STATE OF CONNECTICUT  
CONNECTICUT SITING COUNCIL

IN RE: :  
: :  
A PETITION OF CROWN CASTLE FOR A : PETITION NO. 1559  
DECLARATORY RULING ON THE NEED TO :  
OBTAIN A SITING COUNCIL CERTIFICATE :  
FOR THE MODIFICATION OF AN EXISTING :  
TELECOMMUNICATIONS FACILITY AT 41 :  
PADANARAM, DANBURY, CONNECTICUT : MARCH 24, 2023

RESPONSES OF CROWN CASTLE TO  
CONNECTICUT SITING COUNCIL INTERROGATORIES

CROWN CASTLE		
PROPOSED SITE PLAN (NSB)		
SITE NUMBER	DRAWING NUMBER	REV
CT1443	C-1	3

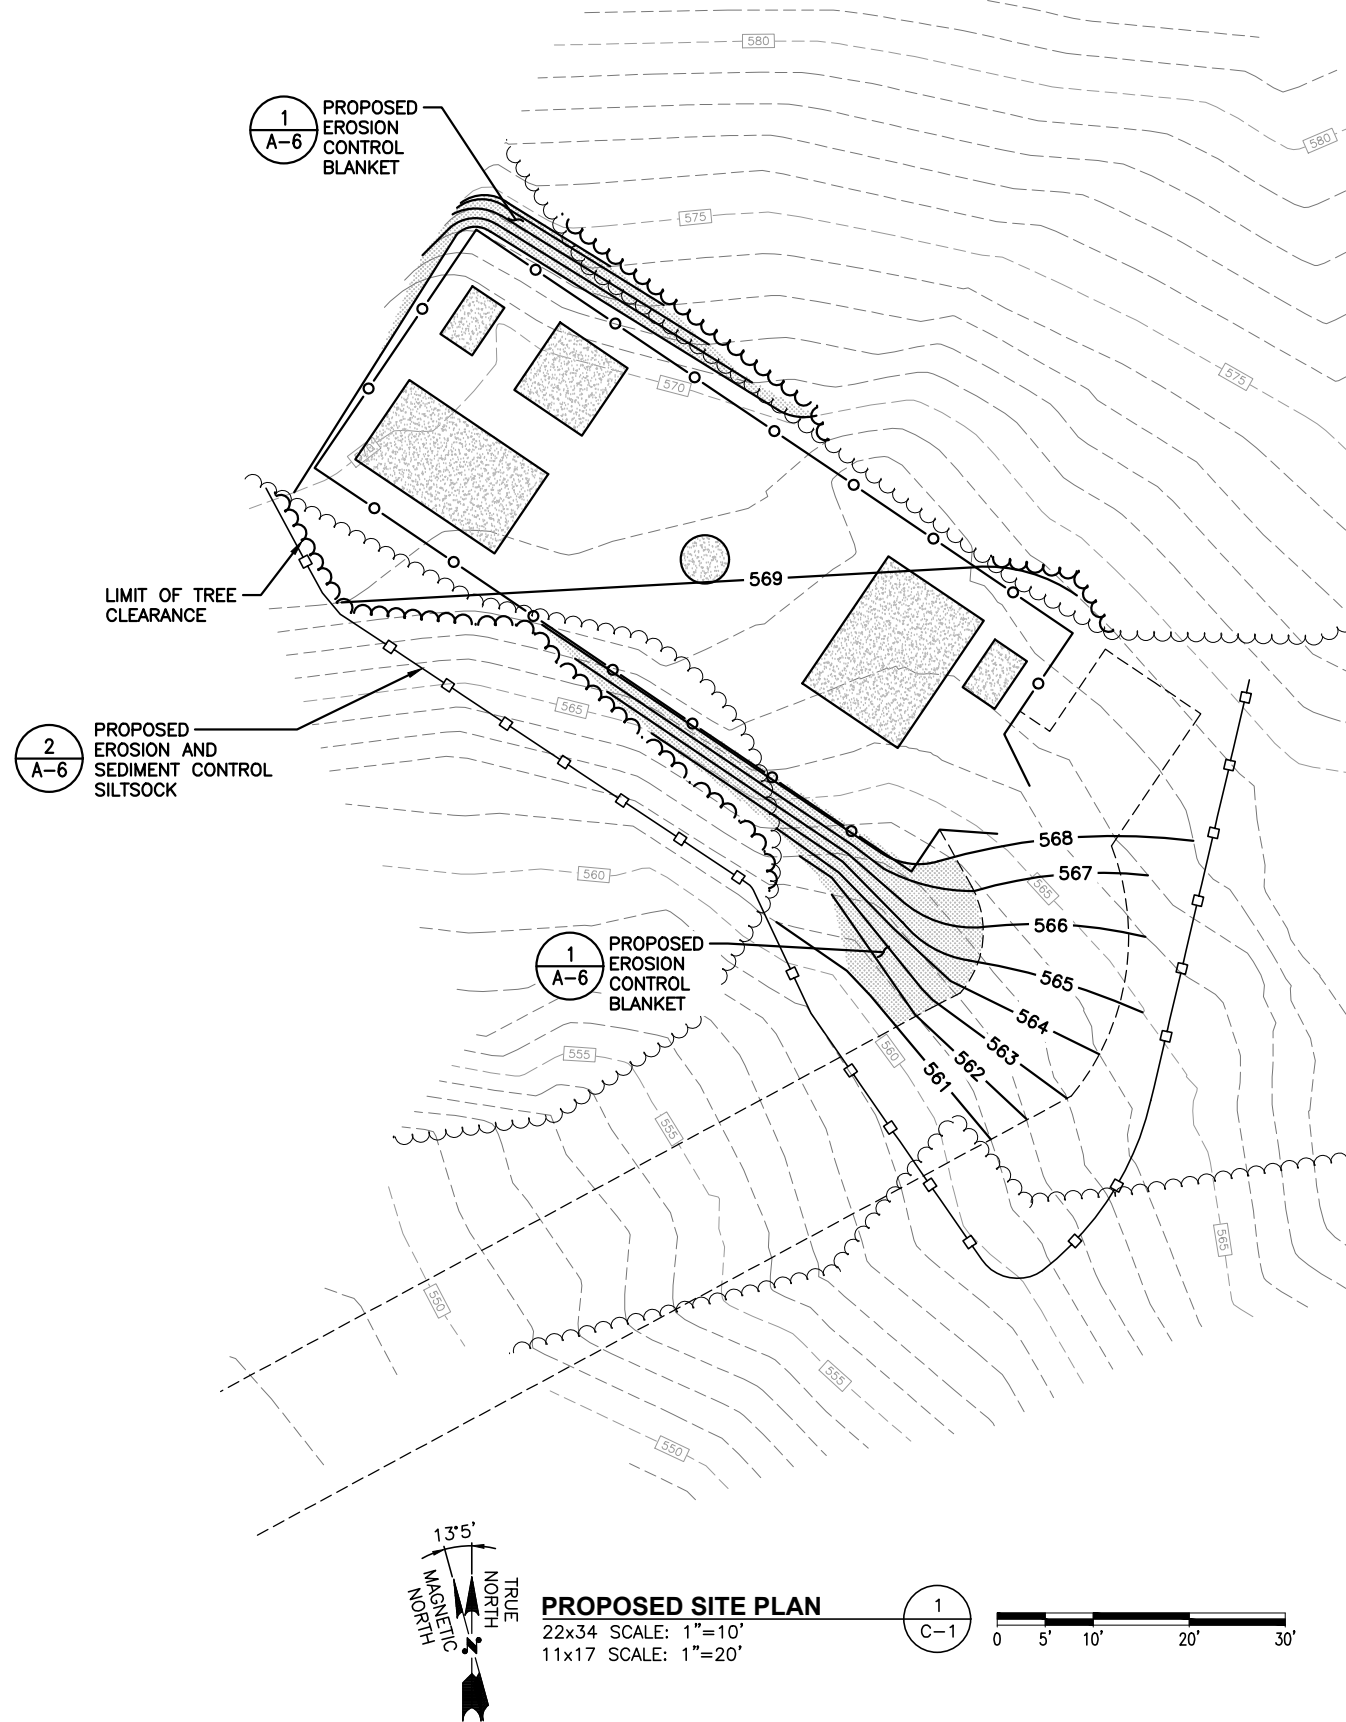
Referencing page 5 of the Petition, clearing and grading is depicted in Attachment 5, Sheet SP-1. Please provide Sheet SP-1.

A revised set of drawing is included in Attachment 3. Plan Sheet C-1 includes site grading.

Leaf-On Comparison Viewshed - Imagery

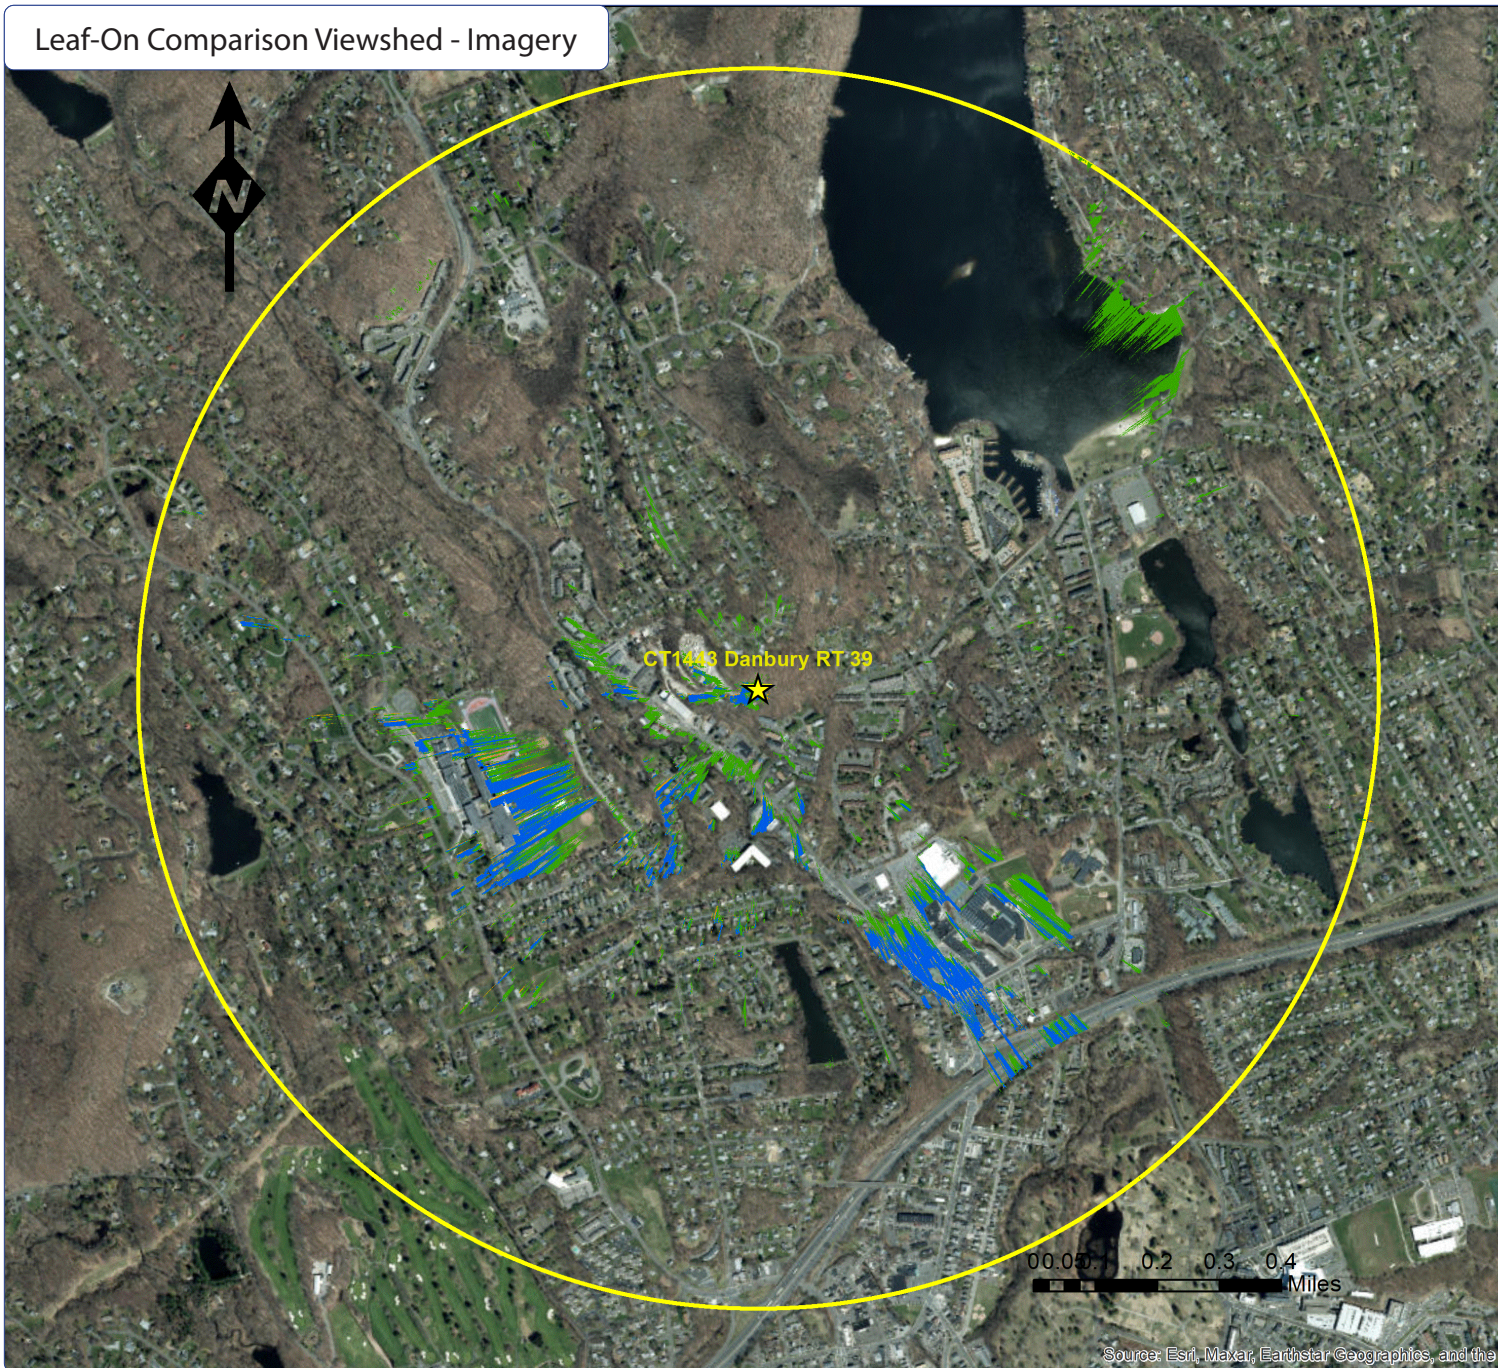
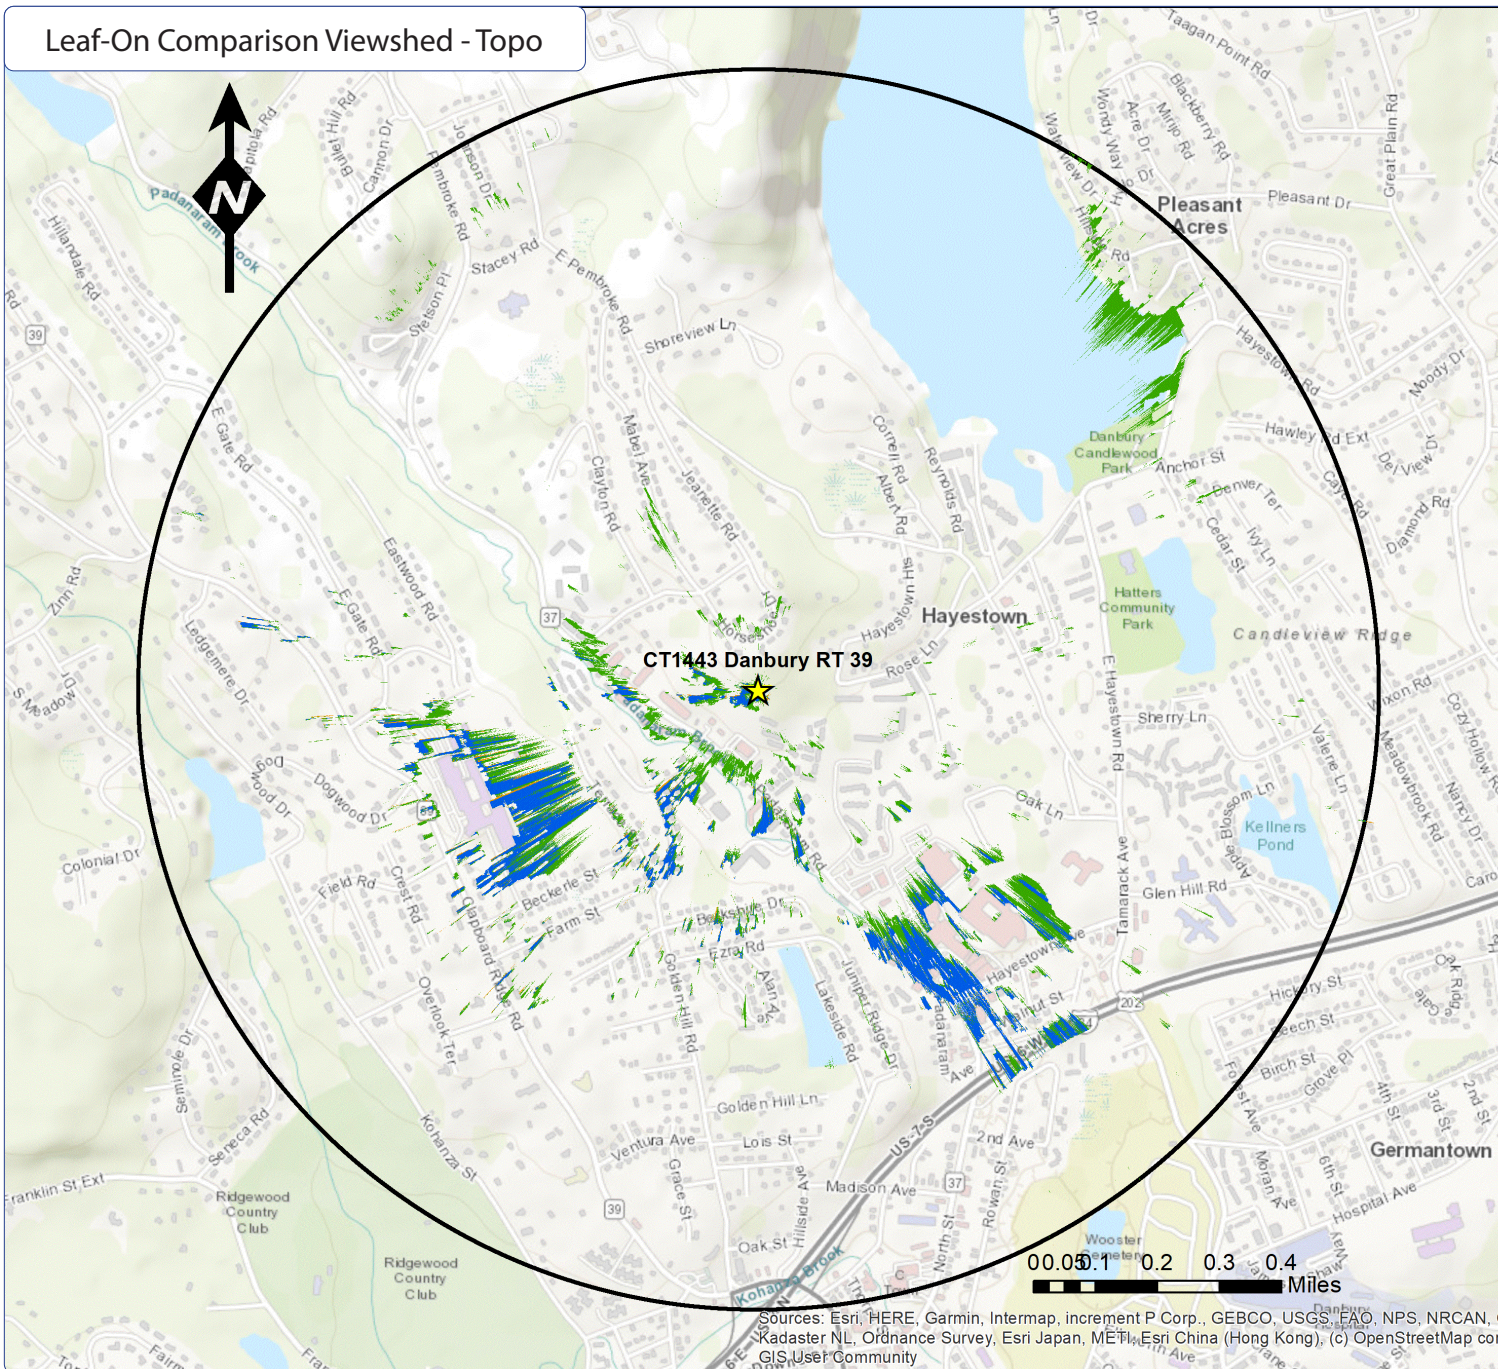
The Council's June 10, 2005 Declaratory Ruling and May 8, 2006 Post Construction Report on Petition 712 (attached) indicated year-round views of the 80-foot tower from Route 37 to the west and seasonal views from the condominiums to the south. How many acres of additional visibility would result from the construction of the proposed replacement tower? Characterize the additional visibility from the surrounding area.

Predicted seasonal visibility (summer, leaf-on conditions) of proposed tower as compared to the existing tower is estimated to be from an additional 34.5 acres or 1.72 percent of the study

area. Additional areas of visibility are mostly contained around areas of previous tower visibility, with more visibility as you move closer to the site. Additional views are predicted in the commercial/mixed use areas along Route 37 immediately adjacent to site. Small areas (less than 300 square feet) are predicted to be scattered within the multi-family housing complex to the south-southwest. These specific views are predicted to be intermittent and of the uppermost portion of the tower. Predicted year-round visibility (winter, leaf-off conditions) of proposed tower as compared to the existing is estimated to be from an additional 77.4 acres or 3.85 percent of the study area. Due to the nature of this type of winter view (thru existing tree limbs and foliage) the additional views are mostly scattered within the study area with larger areas of predicted visibility in the open areas around the commercial area to the southwest, the field area of the Danbury High School and within Lower Pine Cove. These specific views are predicted to be distant and partially obscured. Attachment 4 contains viewshed comparison packages for both leaf on and leaf off conditions. These maps compare predicted visibility of the existing tower height (shown in orange) and location to proposed tower height and location (shown in green) and indicate where both towers are predicted to be visible (overlap in blue).
